AIRWORTHINESS DIRECTIVE

TYPES AFFECTED: Glasflugel - Club Libelle 205
Hornet
Mosquito
Mosquito B
Mosquito 304

SUBJECT: Elevator drive/tailplane mounting bracket

GFA AD 327	Issue 1
17.12.1987	Sheet 2 of 2

FIG. 1.

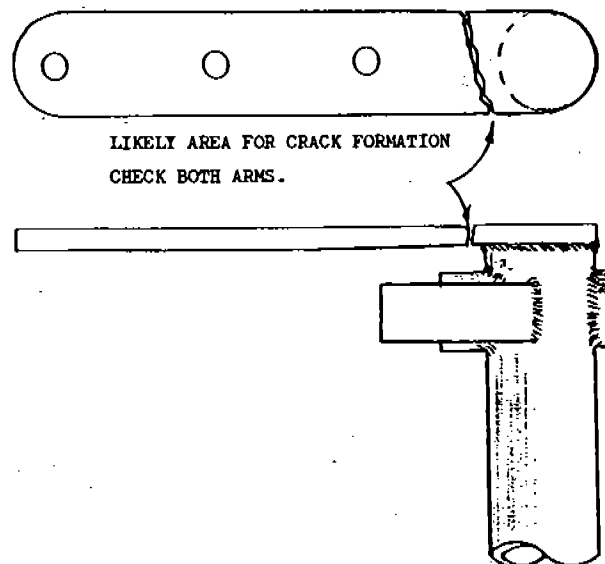
Visually inspect the elevator drive bracket for possible cracks (see Fig. 1) whilst twisting the two elevator halves against each other.

If the bracket is cracked or deformed the sailplane must not be flown.

FIG. 2.

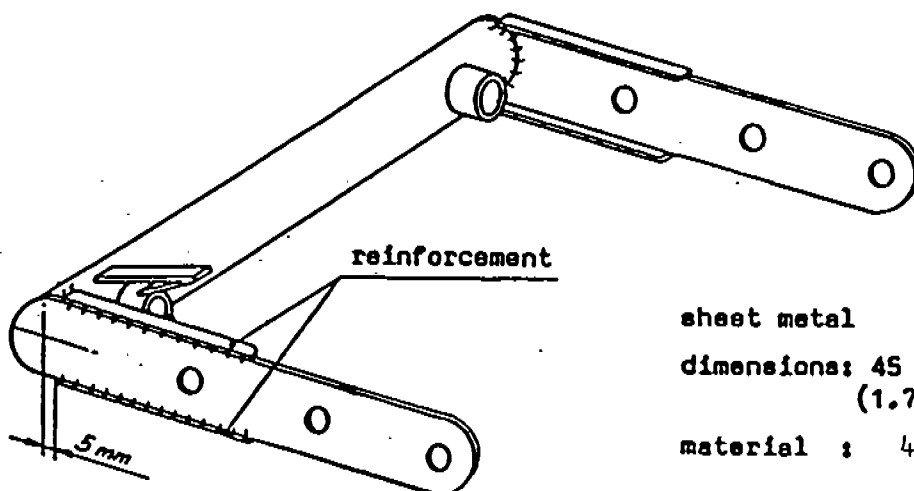
Remove the elevator drive bracket and reinforce the two arms with additional metal strips (see Fig. 2)

If the bracket arms are twisted out of line they may be carefully straightened (hot) and checked for cracks before welding on the reinforcements.

sheet metal

dimensions: 45 x 5 x 1.5 mm
(1.77 x 0.20 x 0.06 in.)

material : 4130 steel

Weld with T.I.G. process
